**Administrative Documents**  
**WATTS BAR EXAM 2002-301**

**50-390**  
**NOVEMBER 26 &**  
**DECEMBER 9 - 13, 2002**

Attached are the facilitie's marked exam questions. All comments were incorporated into the final exam.

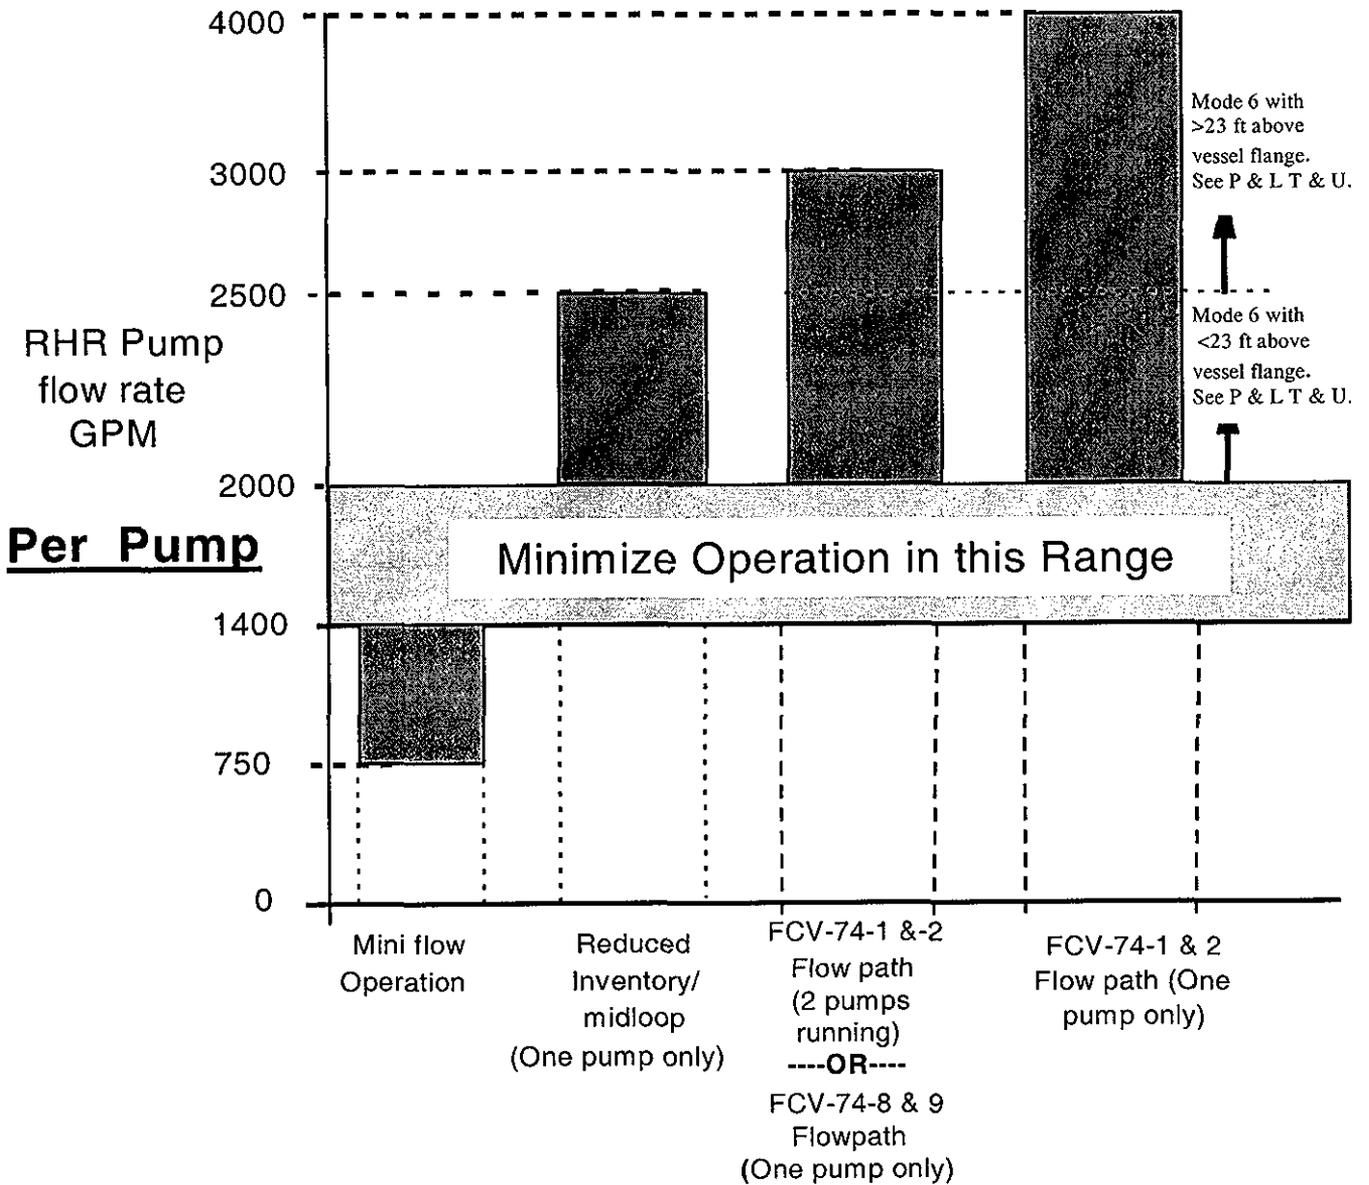
normal midloop level 718'6" to 719'

normal flow 2000-2500 gpm
